Leveraging Risk Insights in Aging Management

June 2, 2022

Risk Insights for Aging Management

Vulnerability Calculation Results

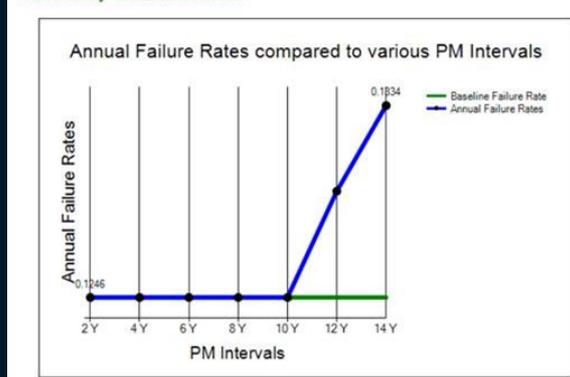
- NEI is proposing to increase the testing frequency by approximately 66% using two relatively undefined data points.
- Explain how using only two data points can establish a meaningful trend to inform changes to testing frequency.

- EPRI PMBD vulnerability study indicates no increased failure rate for cables unless the test frequency is > a 10-year test period.
- EPRI review of industry test data since 2009 had no instances of long-term wetted cables failing when tested on a 6-year frequency, and very cables that tested “good” did not test less than “good” on subsequent tests.

EPRI Preventive Maintenance Basis Database Vulnerability Result
